UPPER UWCHLAN TOWNSHIP  
PLANNING COMMISSION  
AGENDA  
**March 9, 2023**

RE: 301 Park Road – P.J. Reilly Contracting, Inc.  
Proposed Headquarters Building  
Preliminary Land Development Application  
Upper Uwchlan Township  
WAI Project 2021-231

We are in receipt of your review letter dated December 2, 2022 and have the following responses:

**BY**  
MRS

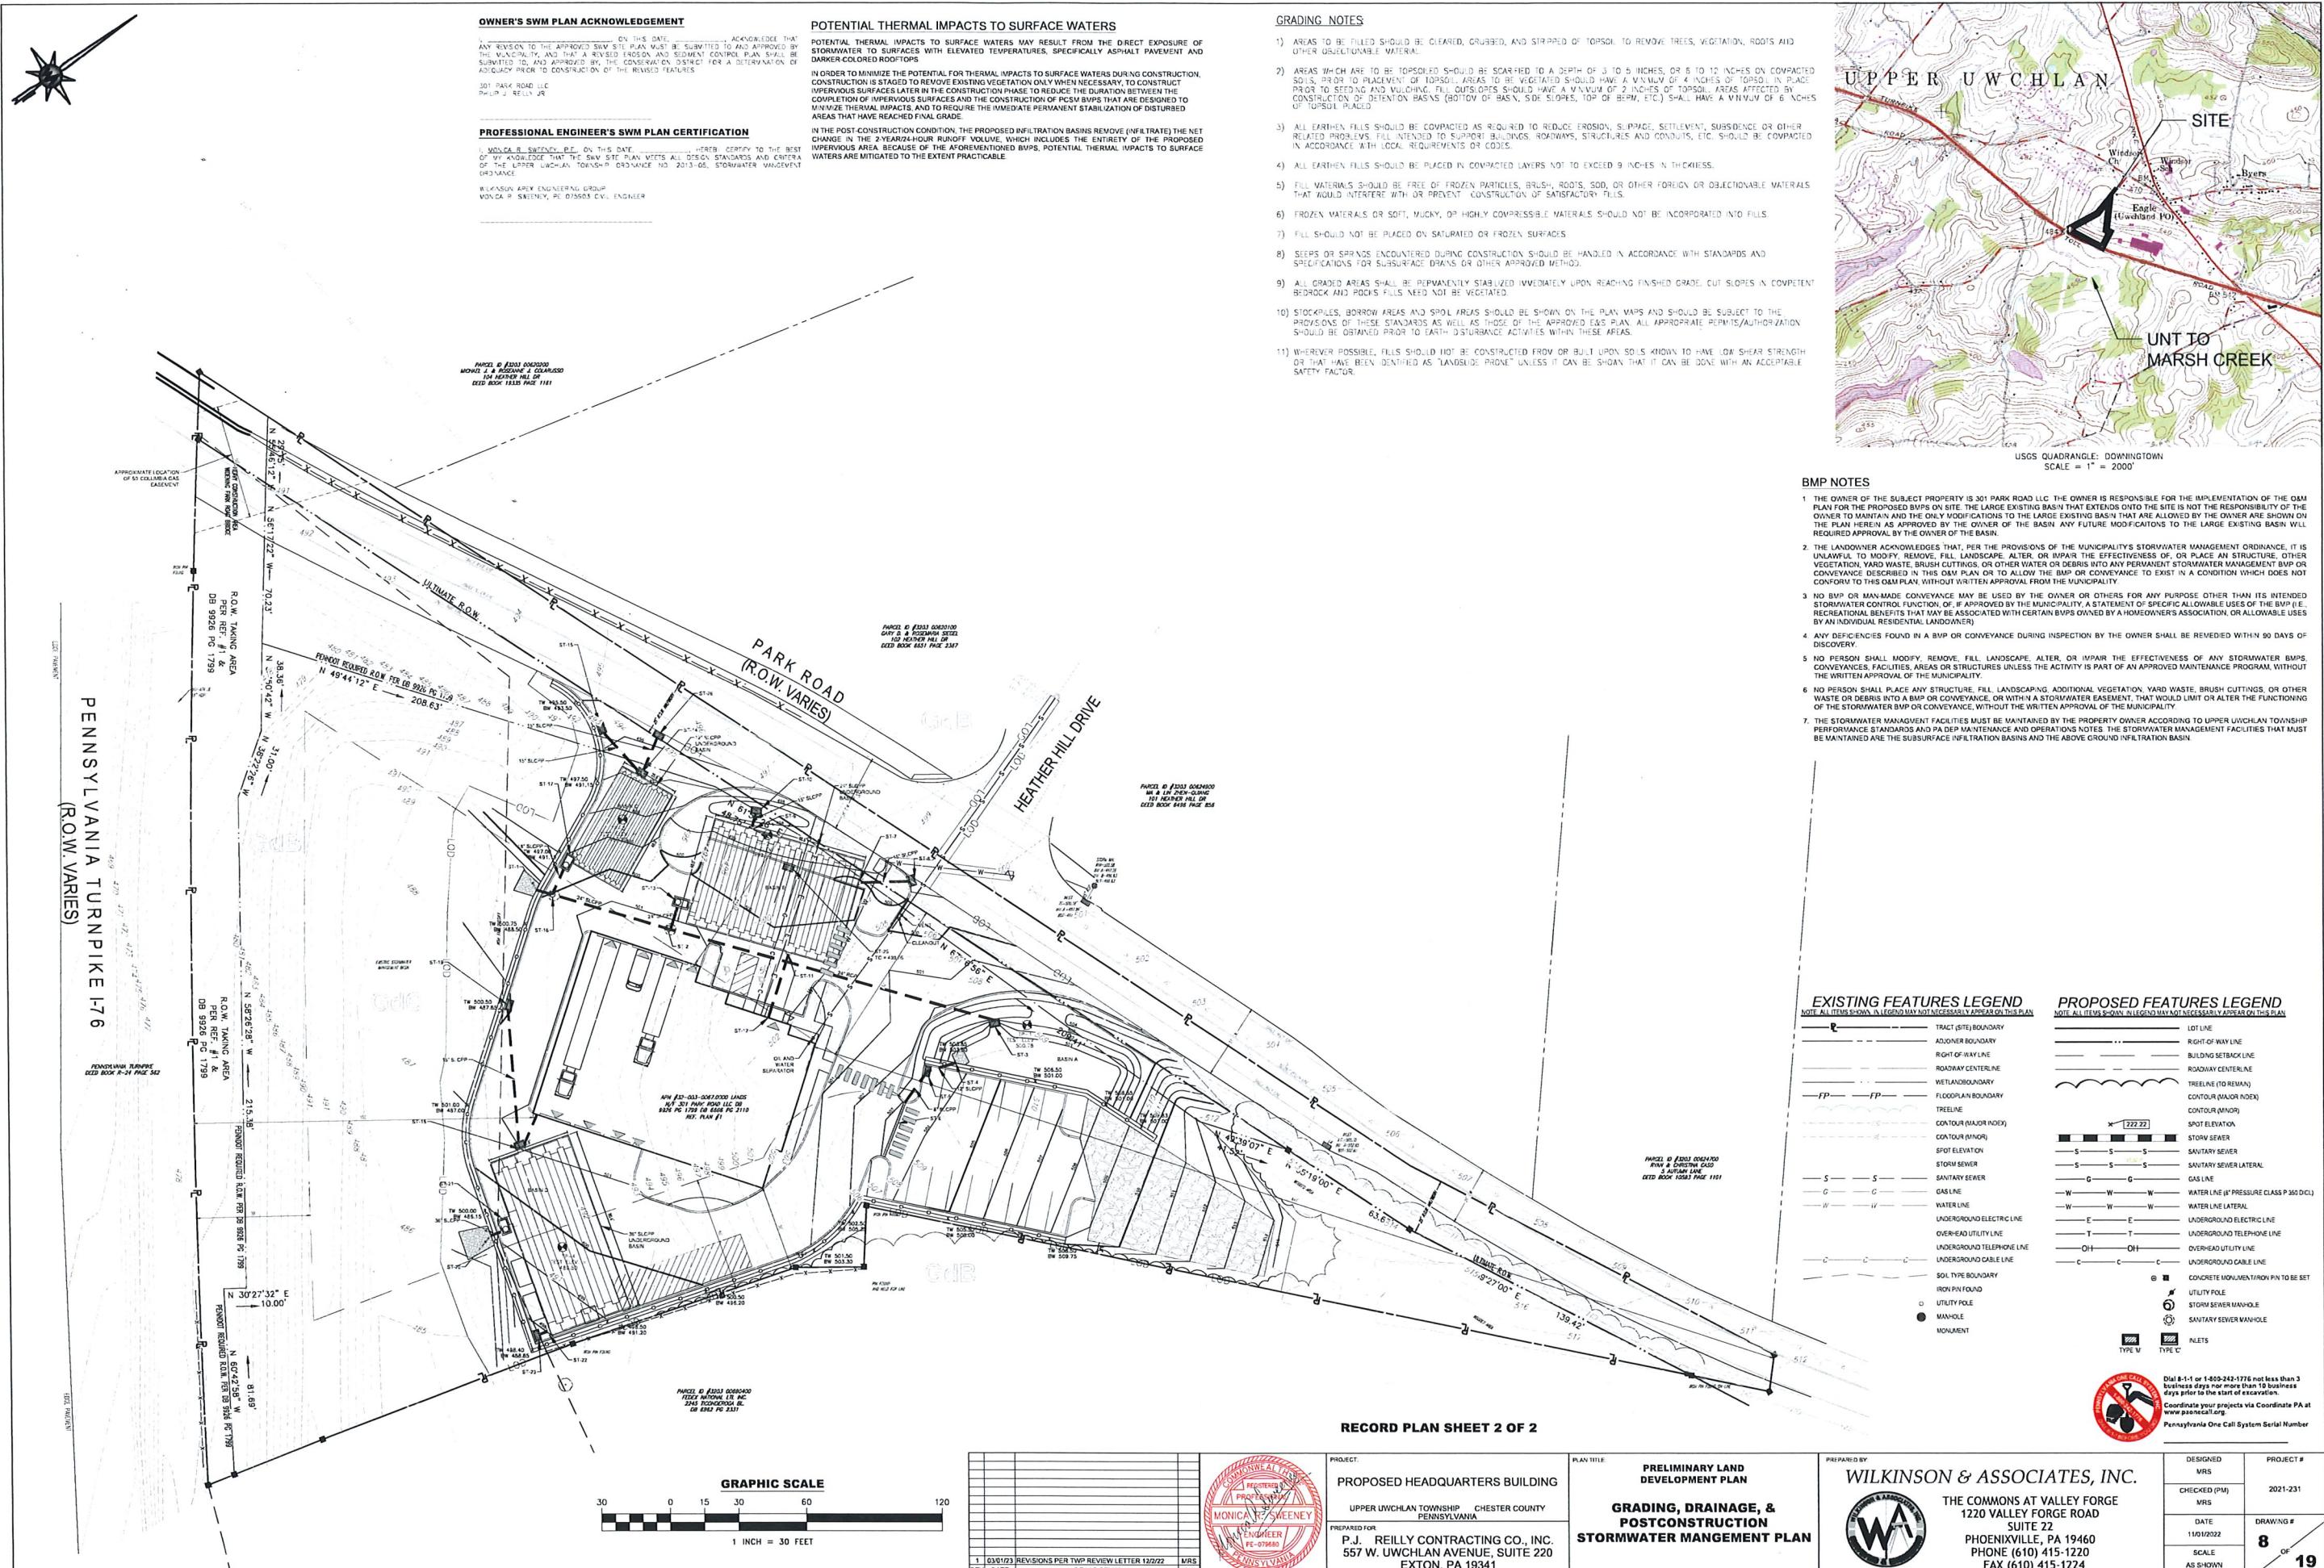
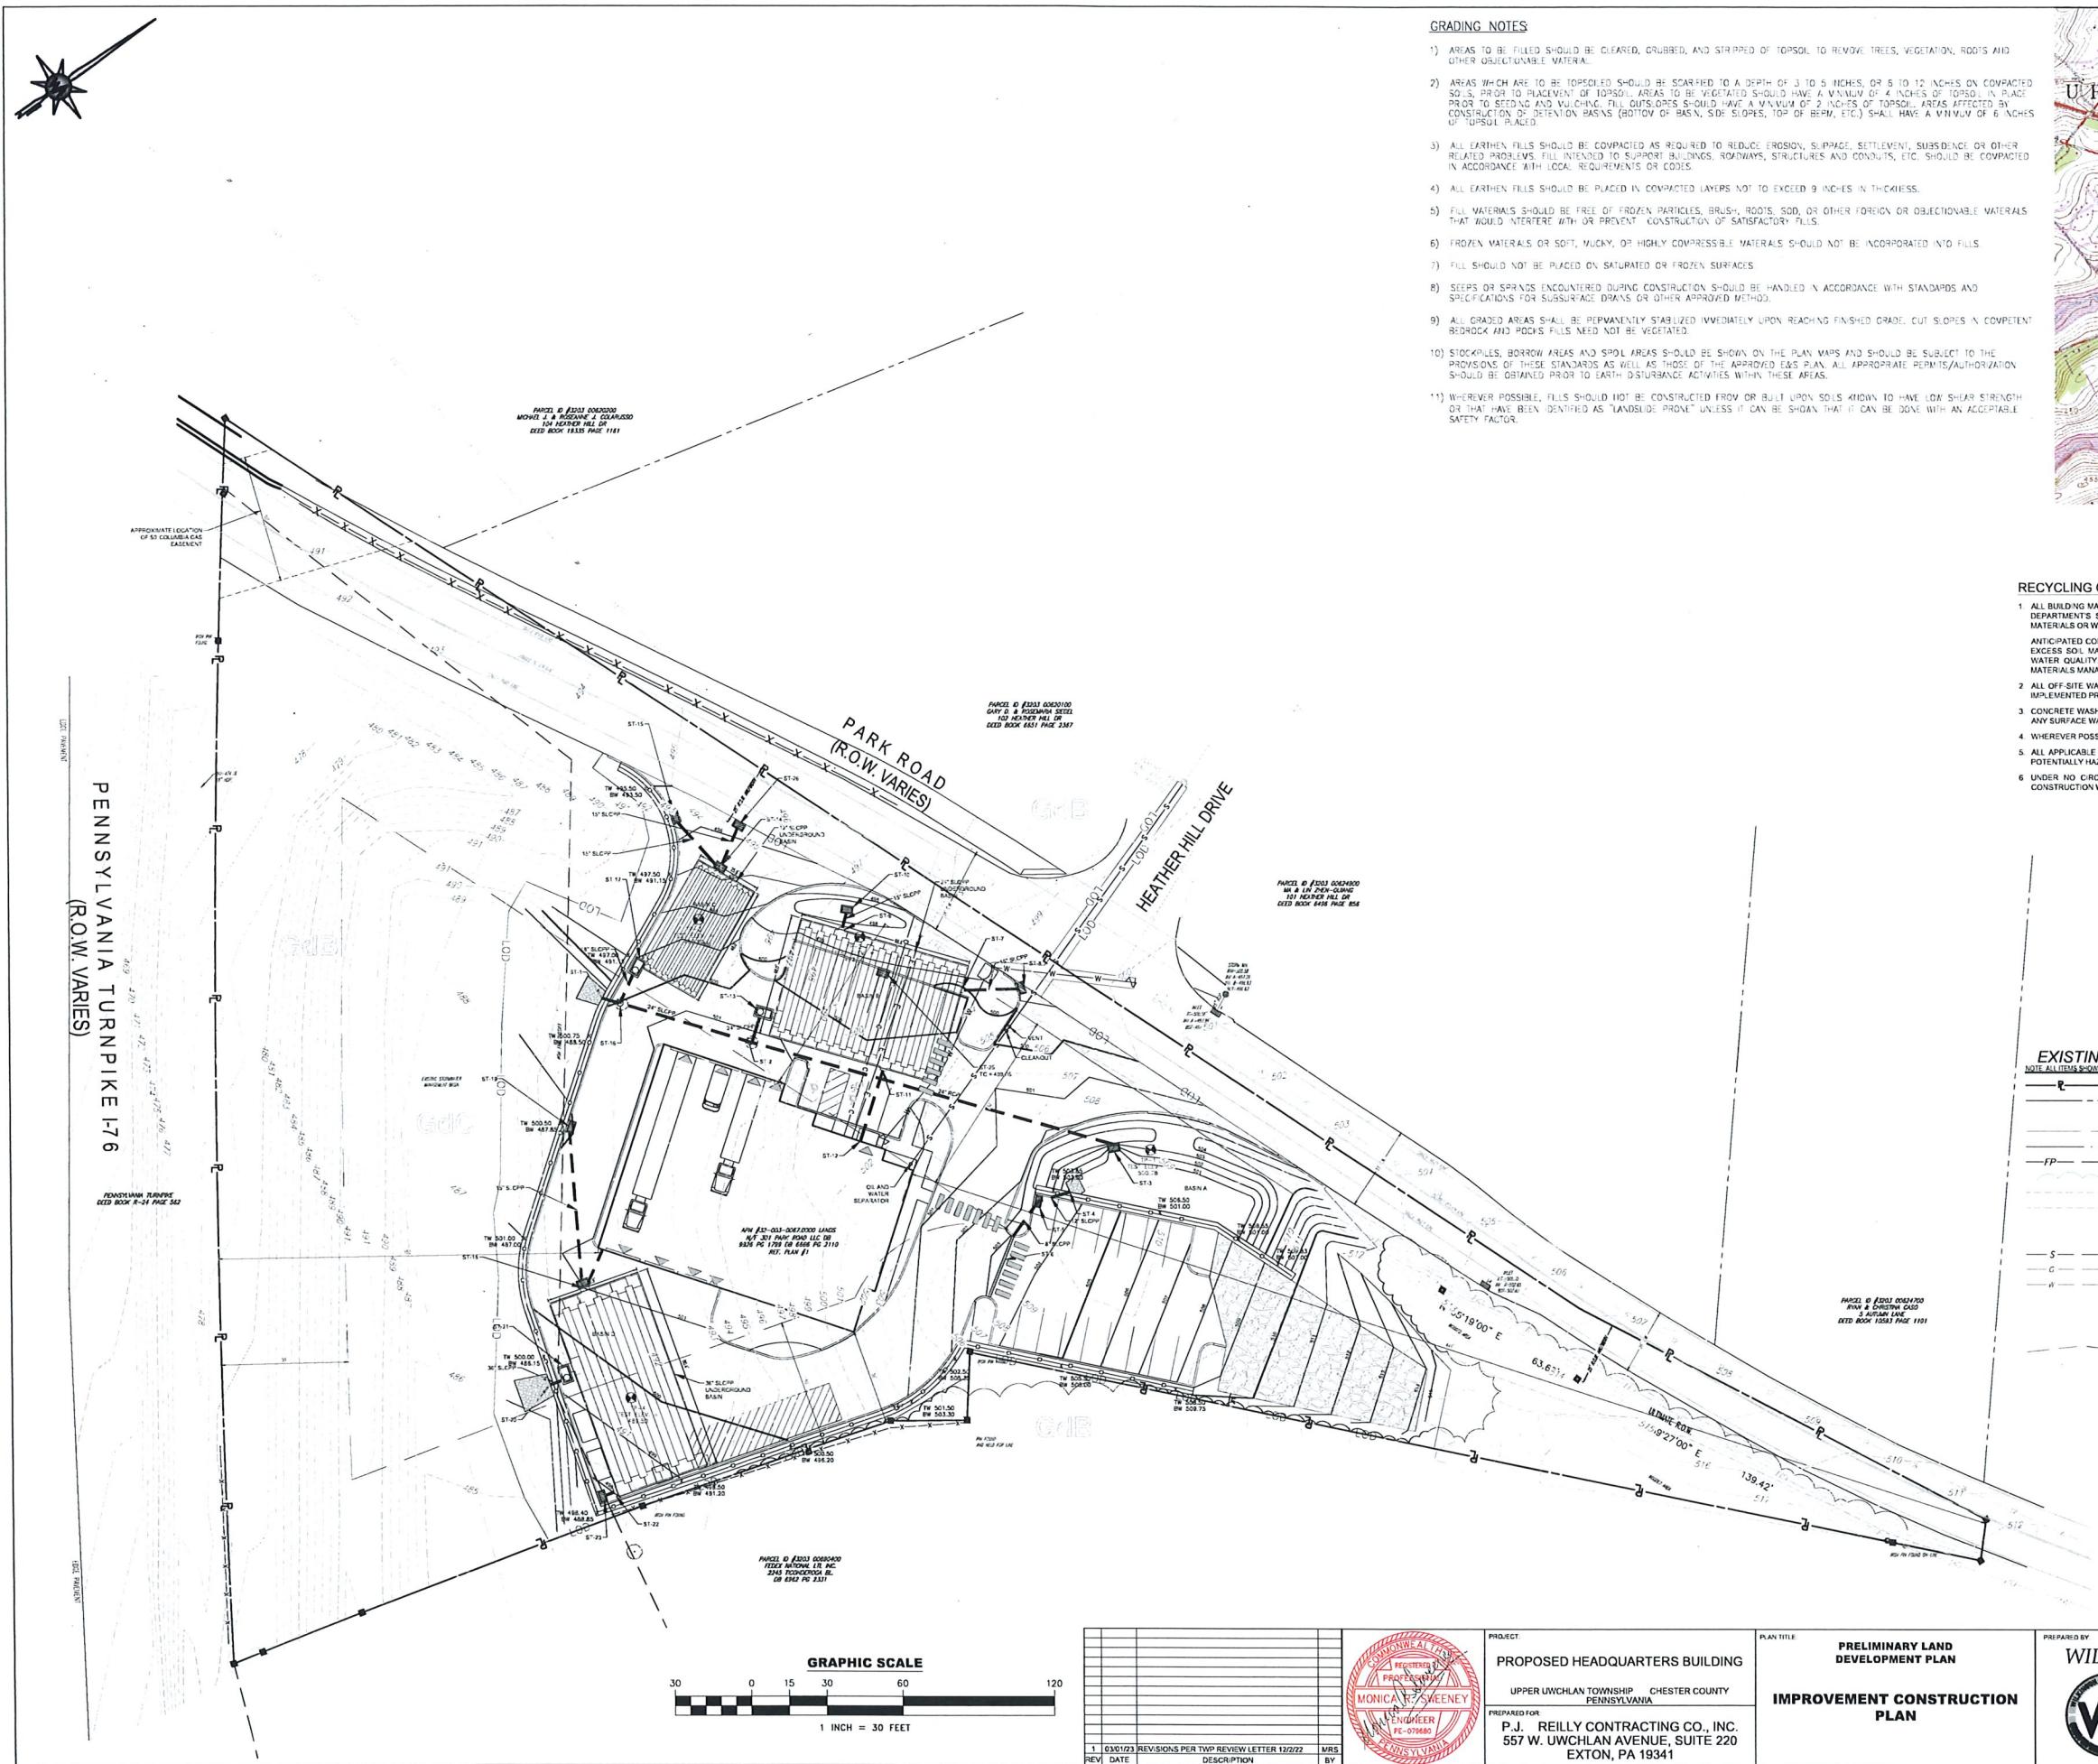
3. Revise the "Site" location on the Zoning Map on Sheet 1, as it pointing to an incorrect location.

6. The location of subject property on zoning insert map on sheet 1 is misrepresented. We strongly encourage correction to avoid any confusion.

*The site location on the Zoning Map on Sheet 1 has been revised.*
